**SERVICE BULLETIN**

**SB027-0196**

Subject: Lancair IVP main gear box reinforcement  
Date: January 17<sup>th</sup>, 1996  
Ref: None  
Pages: 3  
Status: Mandatory Inspection

**Figure 1**

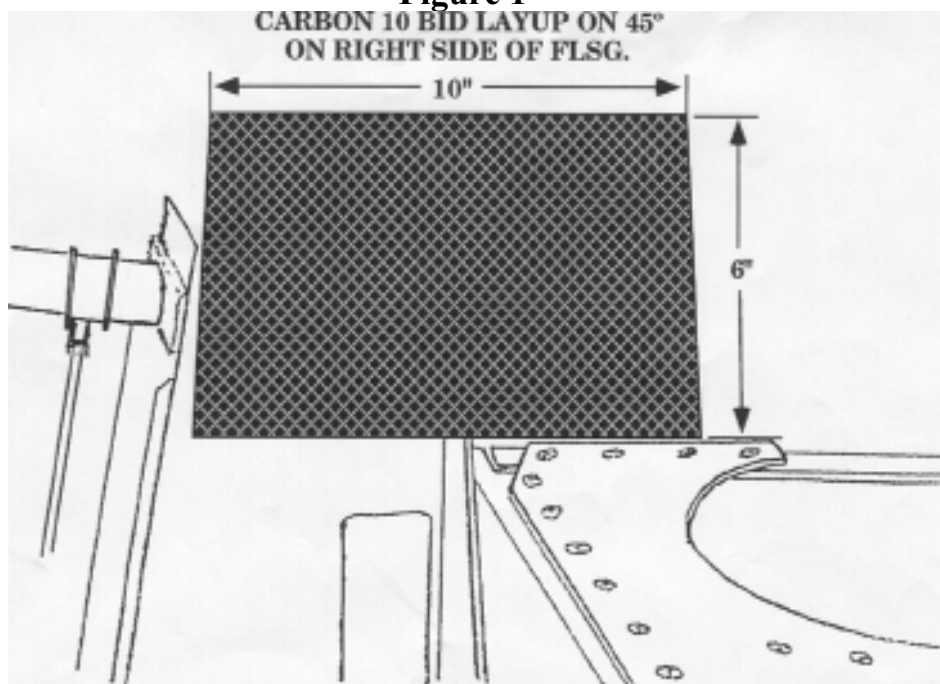
During an inspection of a customer's Lancair IVP during a pressurization test, it was discovered that the 24 BID in the area just above the gear box on the forward right side had debonded. The 24 BID distributes the load of the machine screws securing the GM461-002 bracket and also serves as a stiffener. None of the other IVP's (including the company prototype) have shown similar signs of debonding. However, the following modification is recommended as a precautionary measure.

**Note:** This change is only considered mandatory for the earlier fuselages without the factory pre-installed 20 BID prepreg reinforcement (Ref. Page. 19 -51).

**1. MICRO BUILD UP AROUND BRACKET BOLTS**

Use just enough micro to allow the carbon to lay down nicely when it is applied.

**2. INSTALL 5 BID OF CARBON ON THE 45°**

**3. USE MICRO AS CORE MATERIAL TO FILL ALL THE WAY TO THE EXISTING CORE. YOU MIGHT WANT TO DO THIS IN 2 STEPS.**

Do in 2 steps to keep the micro from going into a exothermic reation.

**4. INSTALL ANOTHER 5 BID OF CARBON AT 45°**
